TRI-LAKES MONUMENT FIRE PROTECTION DISTRICT

LOCAL AMENDMENTS
INTERNATIONAL FIRE CODE – 2009
December 5, 2012

FIGURE D103.1 MINIMUM DEAD-END FIRE APPARATUS ACCESS ROAD TURNAROUND.

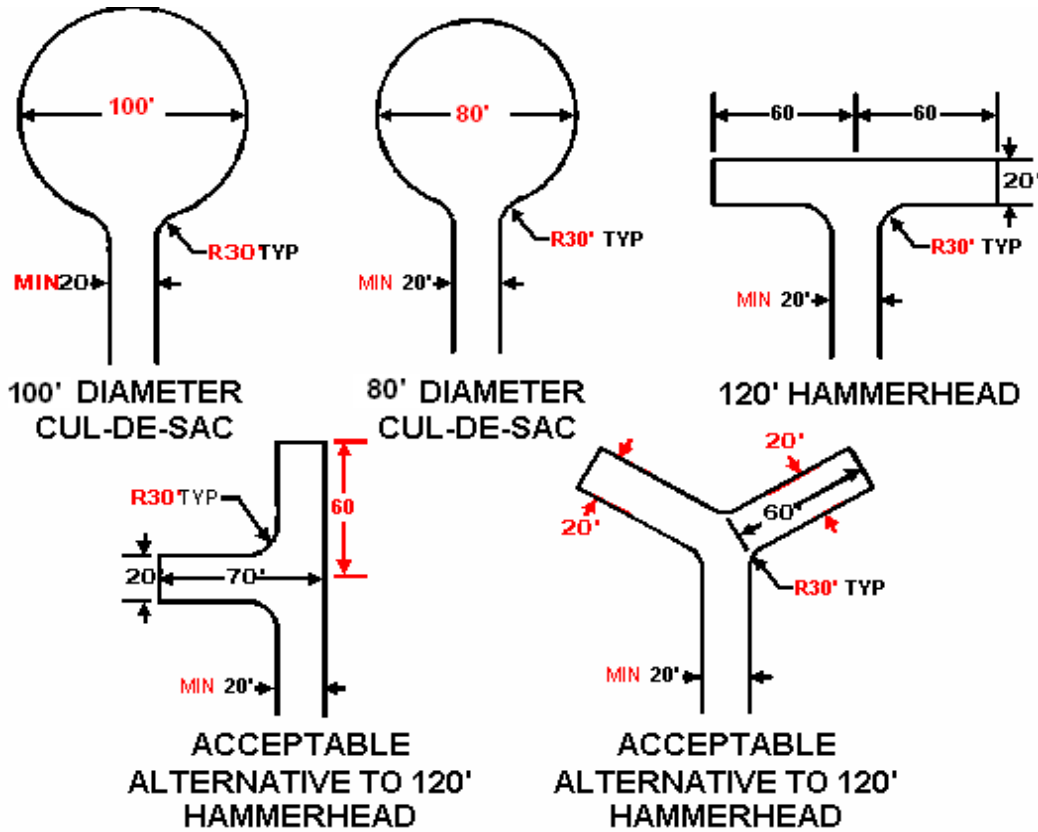
Figure D103.1. Dead-End Fire Apparatus Access Road Turnaround. Delete Figure D103.1 and replace with the following:
